## SERVICE BULLETIN

**NUMBER:** 12-279-20R

**SUBJECT:** Outer Door Handles- Chrome Finish Peeling

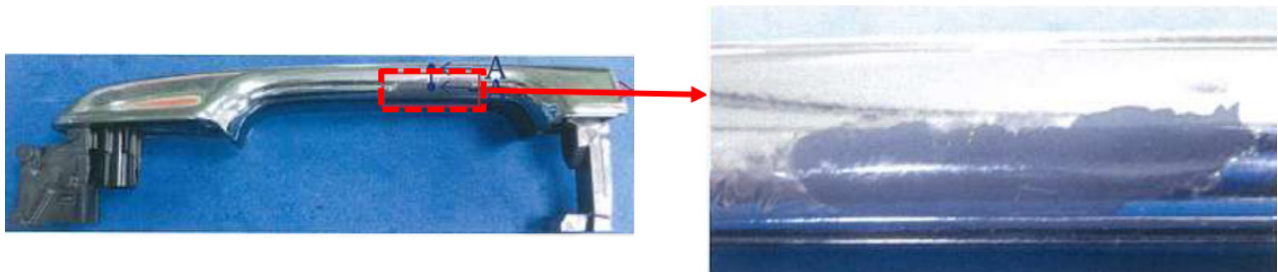
This bulletin announces availability of new outer door handles to address isolated concerns of the chrome finish peeling. Some hand creams and lotions contain oleic acid which may penetrate the chrome finish and cause it to peel as shown in the example photos below. The new handles utilize a plating with increased durability and improved resistance to oleic acid.

The new door handles were incorporated into production starting with the following VINs:

Model	Starting VIN
Impreza 4-Door	L1607753
Impreza 5-Door	L3716116
Crosstrek	LH214419
Forester	LH455974
Ascent	L3458324
